SERVICE MEMO

Number: JDE 2024-05
Dispenser(s): Procure
Title: Procure Unit Change 55126419 PROCARE SOUL SM BLK KIT RIGHT JDE

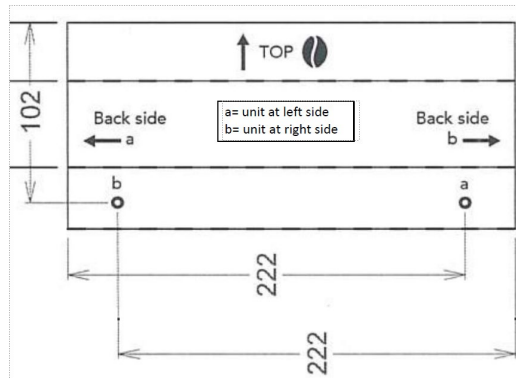
1. The vendor material number changed from 040447-00000007 into **040447-00000039**
2. Description will change from PROCARE SOUL SM BLK KIT RIGHT JDE into:
PROCARE SOUL SM BLK KIT R/L JDE
3. Reason for this changes (point 1 and 2) is that 55126419 is now also usable for the left side if it is not possible to have the fridge+procure unit on the right side, which is preferable.
4. Difference with the 'old' unit is that the new side right panel for the machine is not in the kit (55126419) anymore. This is replaced by a template for drilling a hole on the right place for connecting the procure unit to the machine. Example of the template see below:
